## **ALERT SERVICE BULLETIN**

**206L-20-184**

Revision C, 14 January 2021

**SUBJECT:** SEGMENTED TAIL ROTOR DRIVESHAFTS 206-040-369-001/-101, 206-040-365-001/-117/-125 WITH BONDED ADAPTERS, PROOF LOAD TEST OF.

**Figure 1 – Example of Tail Rotor Driveshaft Numbering and Index Marking**

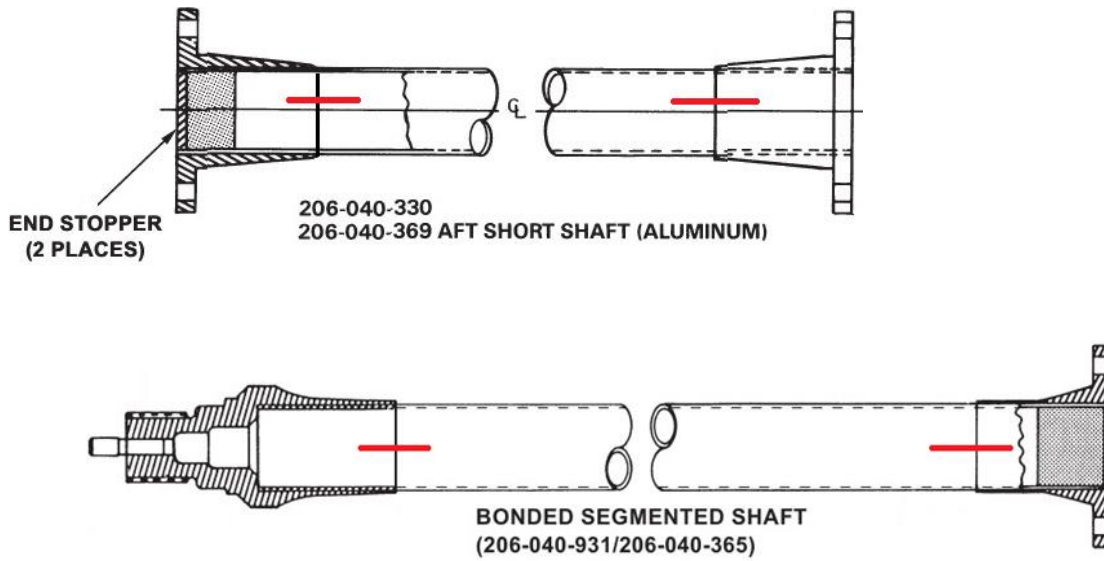
**Revision A** allows failed bonded tail rotor driveshafts to be replaced with serviceable bonded driveshafts that meet the intent of this bulletin and makes corrections to some of the metric dimensions in Figure 1 of this bulletin. **Revision B** introduces a new work aid to hold the forward end of the sliding adapter 206-040-373 used with the forward short shaft 406-040-315-111. The new work aid is not procurable and is to be locally manufactured (Figure 3). **Revision C** corrects the part numbers in Step 11 of the Accomplishment Instructions.
